February 9, 2005

U.S. Department of Transportation
National Highway Traffic Safety Administration
Office of Defects Investigation
NSA-10.01, 400 7th Street, SW
Washington, DC 20590

Enc: Two Photographs of Selector Lever Designs

1986 Chrysler LeBaron Selector Lever

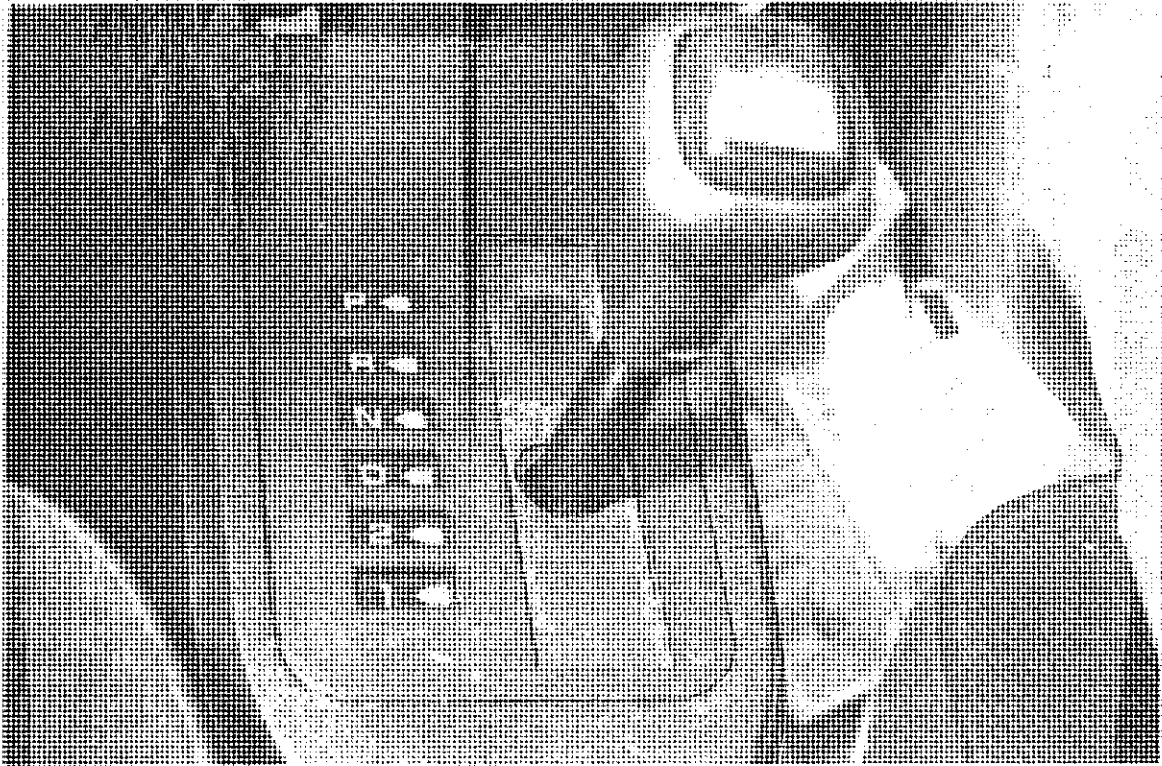
The [REDACTED] incident is only one example of many incidents of this type I have investigated. Accidents of this description occur commonly and can be prevented by a simple modification of the selector lever. The selector lever for the [REDACTED] vehicle is shown in the enclosed photograph. This is a typical console-mounted selector lever. Note that a palm button is used to control movement into and out of PARK. The position indicator (the PRNDL indicator) is vague, hard to read, and, for this vehicle, not illuminated. The indicator is particularly hard to see at night, when the [REDACTED] incident occurred. Observe, for comparison, the selector lever shown for the 2003 Subaru. This design, which is notched and requires the driver to use lateral motion to place the lever into or out of PARK, makes the driver well aware of the selector lever position. This simple, nearly cost free, design will virtually eliminate the confusion where the driver believes the lever is in PARK while, in fact, it is in ILLUSORY PARK.

It is established that drivers rarely use the PRNDL indicator to determine whether they are in PARK. They use the end-of-travel indication. History has shown that this is not a suitable indicator. If lateral motion was required the driver would know with certainty that the system is in PARK.

NHTSA has studied the issue of ILLUSORY PARK for many years. There was a "C2" report issued in the late 1960's. Certainly car manufacturers have improved the selector lever system over time. For example, they now rarely use a flat zone on the contour of the inner manual lever between PARK and REVERSE, while at one time this was common. I suggest that now is the time to require manufacturers to incorporate this notched, lateral-motion design into their selector levers that would virtually eliminate ILLUSORY PARK incidents for those cars that use a console-mounted selector lever. Some, but not all, new cars use lateral motion to control motion of the selector lever. My request is that you make it a requirement that all console mounted selector levers be properly designed with this feature.
